***MODIFICATION REQUEST:
Sydney University Abercrombie
Precinct Redevelopment
Cnr Codrington Street and Abercrombie
Street
(MP07_0158 MOD 2)***

- Modification to the Business School Building

Director-General's
Environmental Assessment Report
Section 75W of the
Environmental Planning and Assessment Act
1979

Figure 4: Proposed Ground Floor

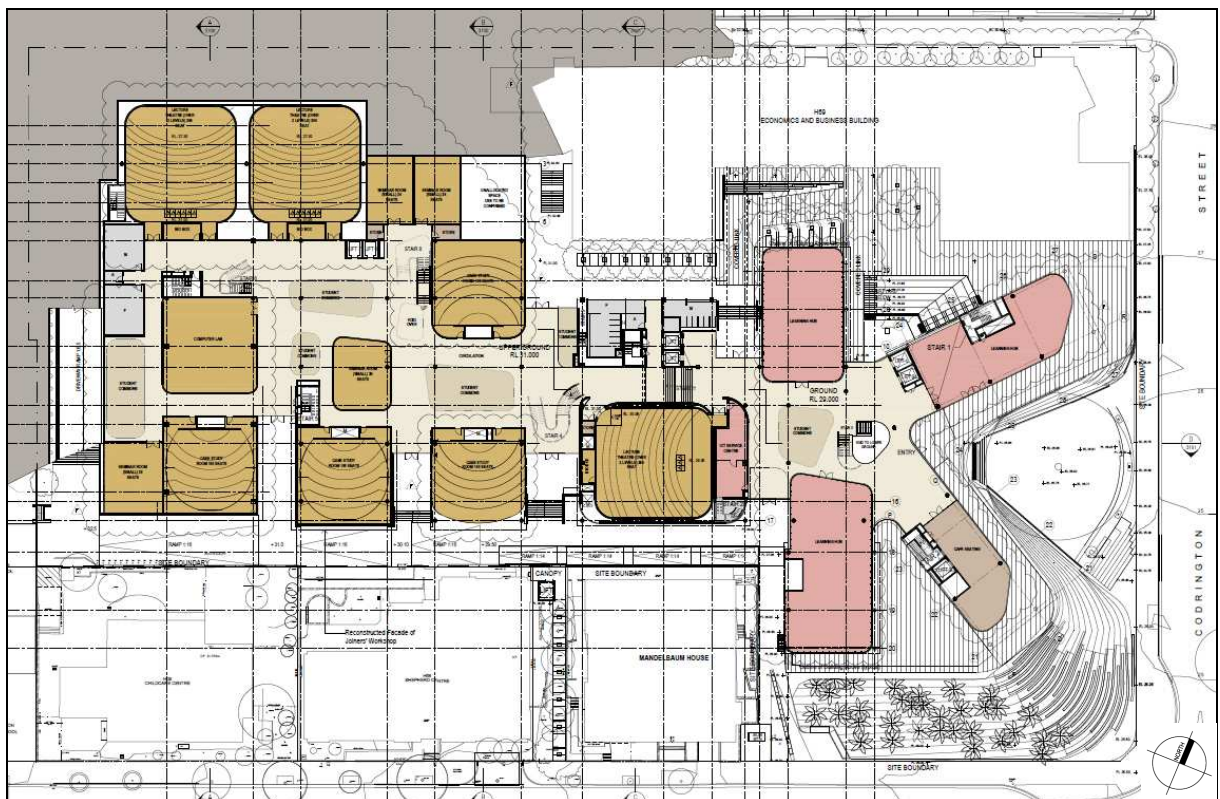
- the relocation of the 550 seat lecture theatre improves access to the front entrance;
- the re-orientation of Blocks A and B is supported;
- the loss of the truncated frontage on the ground floor of Block C appears to result in a loss of open space and remove an architectural feature that links this element to the design of the blocks that project towards Codrington Street;

Council were generally supportive of the proposed building amendments, however council noted that the 'squaring off' of Block C removed the architectural design feature that tied this element of the building design to Codrington Street. In response, the proponent advised that the design change to Block C was required to accommodate an area of 900 sqm for the ground level learning hub, and that the adjoining external terraced area has been enlarged to

offset any loss of passive open space. The corners of Block C have also been rounded to maintain a design link to Blocks A and B (see **Figure 4**).

Figure 7: Basement Exhaust Stack Location

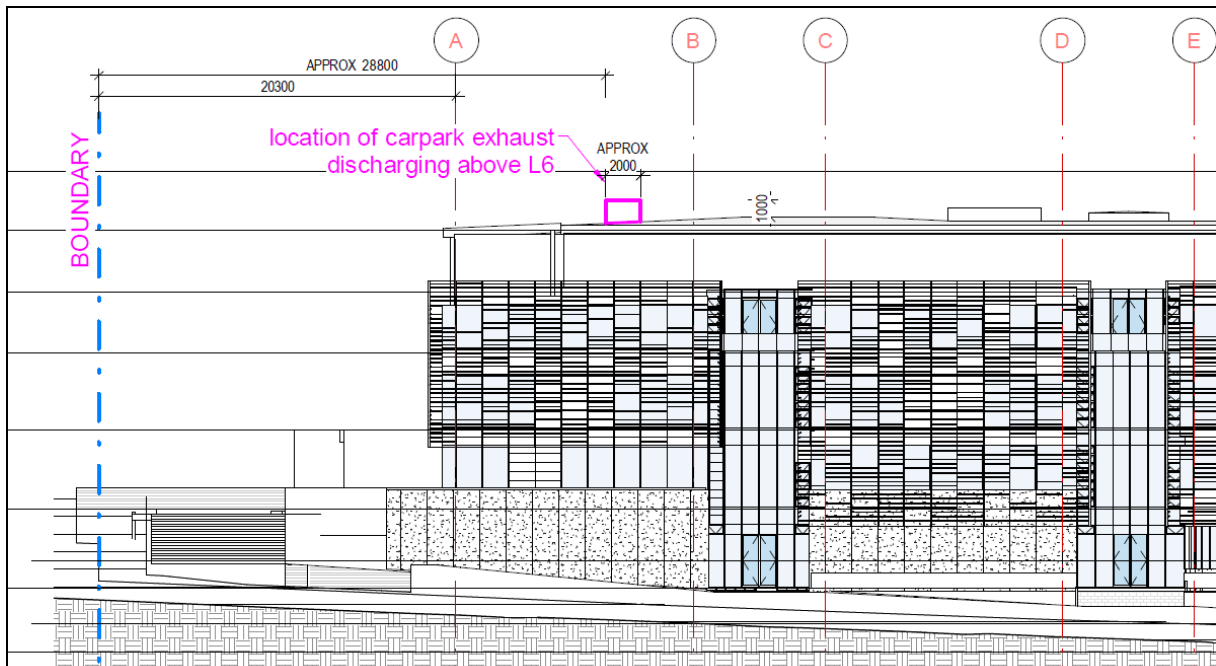
2. The location of the exhaust stack of the car park will release just 9 metres from kindergarten classes which is outrageous and unnecessary and should be moved as far away as possible.	33

With respect to the concerns raised by the public in relation to the basement car park exhaust stack being located 9 m from the common boundary with Darlington Public School, in its RtS, the proponent revised the stack's location, positioning it approximately 20 m above ground level (on top of level 6) and setback approximately 28 m from the common boundary (see **Figure 7**). The substantial increase to the setback of the exhaust stack was designed to achieve an improved amenity outcome for adjoining properties. The department also notes that the 82 space basement car park would predominantly be utilised by post graduate students and staff issued permits to do so, which would restrict undergraduate students and reduce the number of intermittent vehicle movements to and from the car park. In this respect, the department is satisfied that the separation distance is acceptable and will ensure that potential impacts are minimised.

Figure 9: Proposed Centralised Rooftop Plant Area

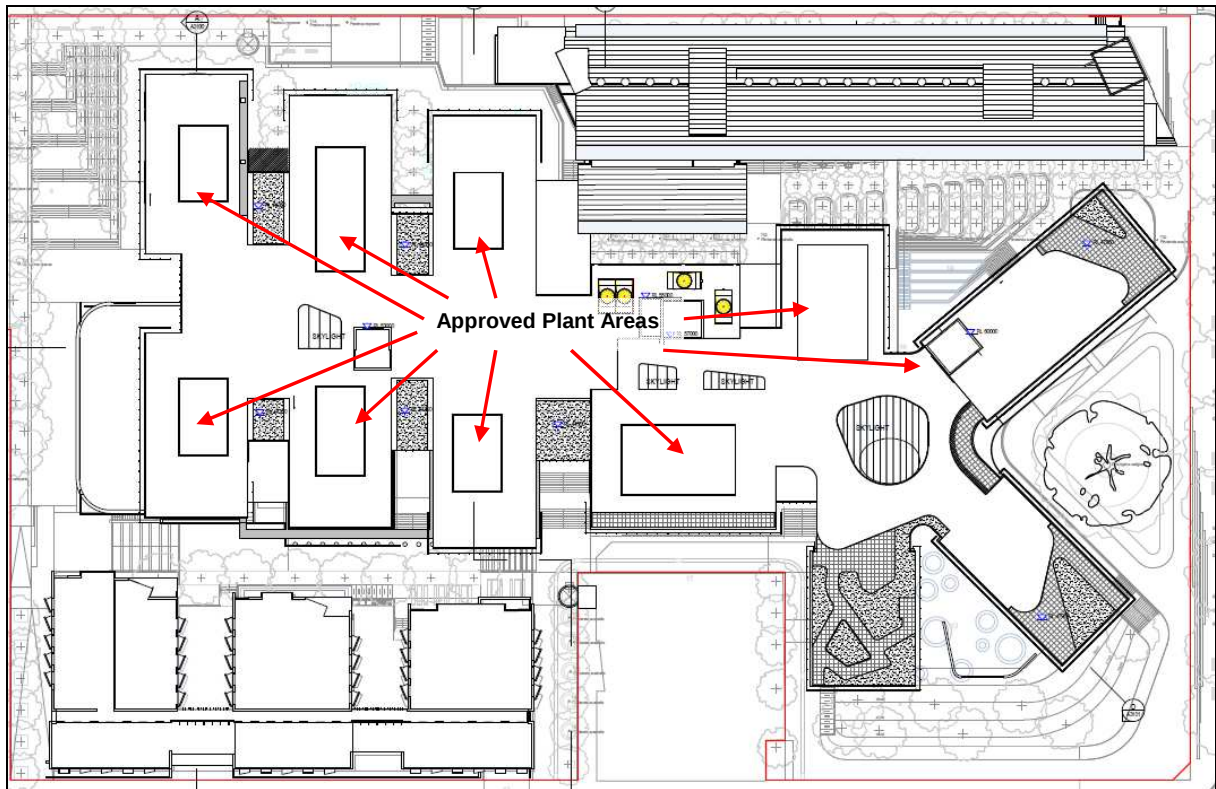
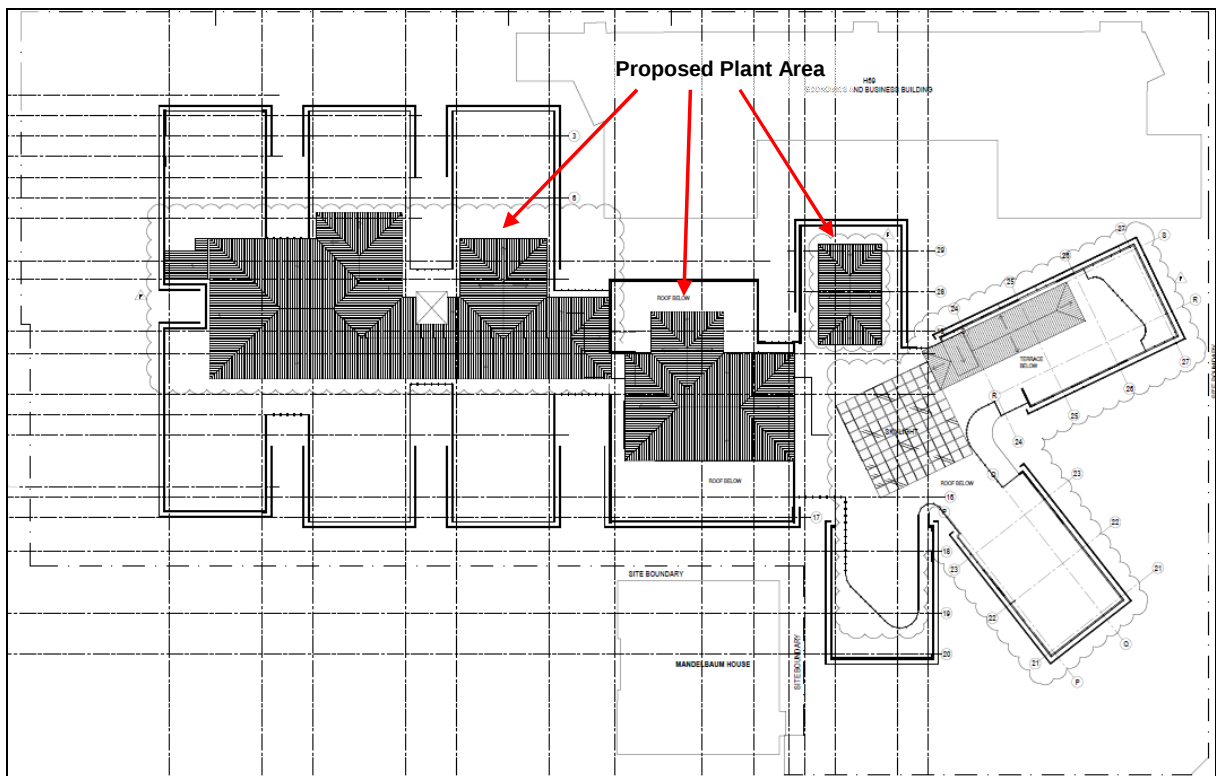
- provision could be made for soft landscaping around the loading bay/substation area;
- the consolidation of the rooftop plant presents a cleaner contemporary appearance, though concern is raised over the length of the louvered external treatment used and the ability to provide some break to the horizontal expression;

A condition was imposed on the original project approval requiring the setback of the rooftop plant immediately behind the adjoining Mandelbaum House to be increased to minimise potential impacts. In addressing this condition, the proponent proposes to consolidate all plant and equipment within a central location of the roof. **Figures 3, 5 and 8 – 13** detail the proposed changes in comparison to the approved development, where it can be seen that the built form on the upper levels has been rationalised, with the multiple built form elements that were present at the edges of each Block reduced.

The proposed building amendments retain the approved building height, however the proposed amendments to the rooftop plant enclosures results in an increase to the height of the plant by approximately 900 mm, though in a central position above Area 2 and Block D. Further, it is noted that the setback of the plant enclosure from the boundary of Mandelbaum House has been increased by approximately 4 m, ensuring that no additional impacts are created. The department also notes that council considered the proposed revisions to present a “cleaner contemporary appearance” to the building.

Figure 13: Proposed Western Elevation

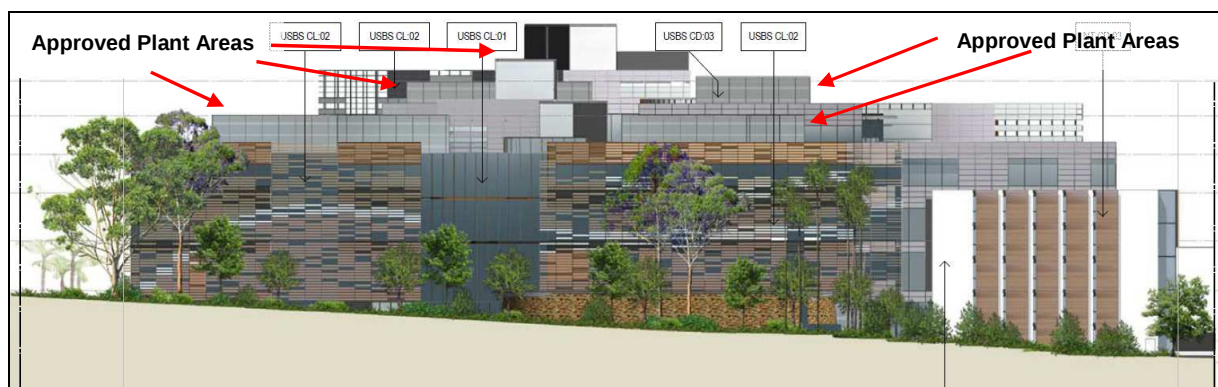
7. Object to the proposed addition of a dining area on Level 4 in Block C which increases the height and bulk of the building on Abercrombie Street.	9
8. The re-orientation of Blocks A and B fronting Codrington Street could possibly have a negative effect on the health of the Sydney Blue Gum tree.	9

Objections were raised by the public regarding additional floor area, building bulk and height due to the proposed dining room on level 4 of Block C. The department acknowledges that a new dining room function has been introduced in Block C (see **Figure 13**). However, the dining room was relocated from Block B and will not result in additional floor area. Furthermore, the department notes that the setback of the entire Block C built form has been increased from Abercrombie Street by approximately 2.5 m, reducing overshadowing and bulk and scale impacts along the street. Moreover, the original approved design included an external louvered screen which wrapped the built form of the building, at times projecting above and around terraced areas.

Having regard to this, the department raises no objections to the proposed amendments to the location of the level 4 dining room to Block C. **Figures 12 and 13** also illustrate the differences between the approved and proposed modifications. It is evident from the figures that the proposed amendments will not result in additional bulk and scale impacts.

Figure 14: Proposed Darlington Lane Substation

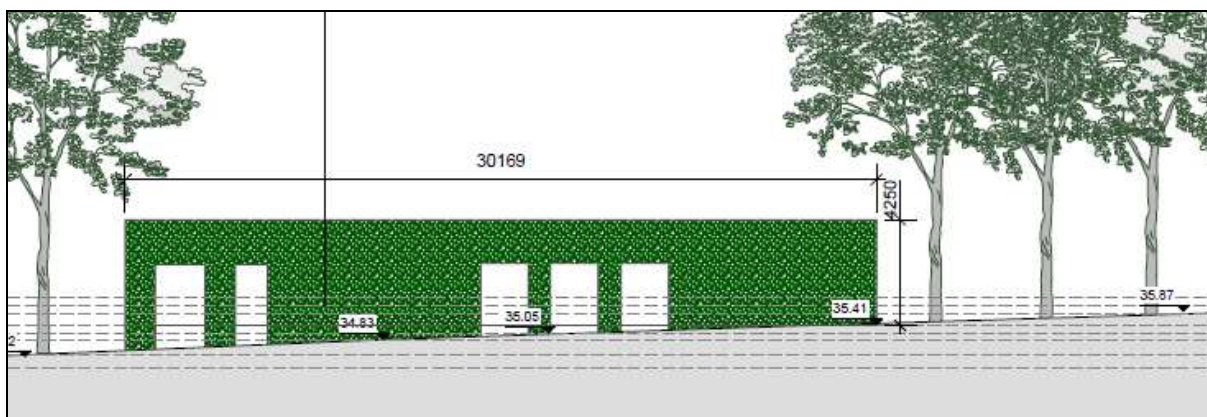
The modification application also proposes to elevate the approved substation from a subterranean position to level 1 (Darlington Lane), and council has noted that it will now become a prominent feature in the lane. Whilst no objections have been raised by council, in response to council's comments, the proponent provided further details with respect to the treatment of the façade of the substation structure, proposing a green wall on the eastern and western façades and surrounding native trees (see **Figure 14**).

The department acknowledges that substation structures are traditionally poorly treated within the streetscape. In this instance, whilst its elevation to Darlington Lane will make the structure more prominent, the proponent's proposed treatment response is considered acceptable and will assist in softening its appearance within the Darlington Lane streetscape.

Figure 14: Proposed Darlington Lane Passing Bay

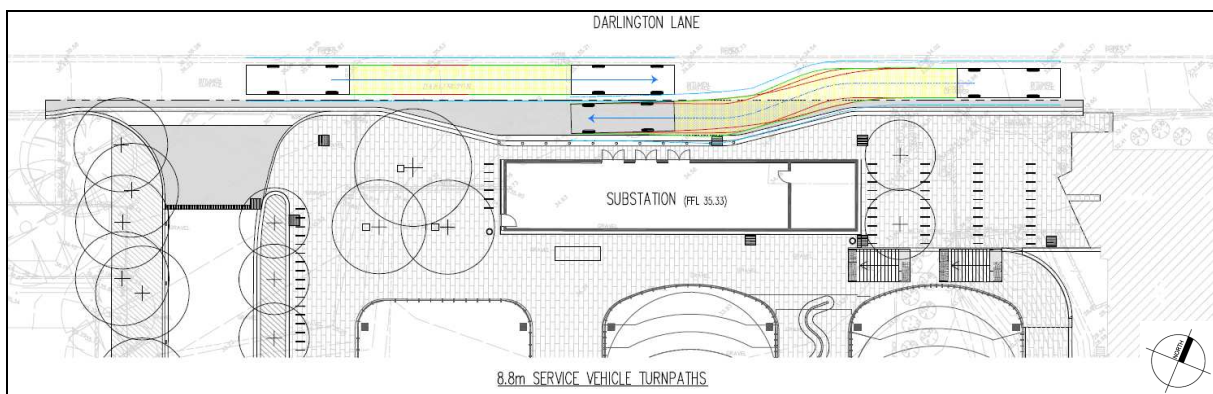
Although not proposed as part of this modification application, the proponent proposes that one-way traffic conditions be implemented along Darlington Lane, from west to east (Golden Grove Street to Codrington Street), to better accommodate the future operational access arrangements. Council has provided in-principle support for the amendments to the traffic conditions, though advised that this would require separate approval from council's local traffic committee. In the meantime, council requested that an appropriate traffic solution be provided in the interim to ensure safe two-way movements are maintained along Darlington Lane, suggesting the creation of a passing bay.

Within the proponent's RtS, a passing bay was proposed, that will provide sufficient passing room adjacent to the proposed substation enclosure (see **Figure 14**). In reviewing the RtS, council noted that proposed turn paths of the passing bay appear to meet the required standards.
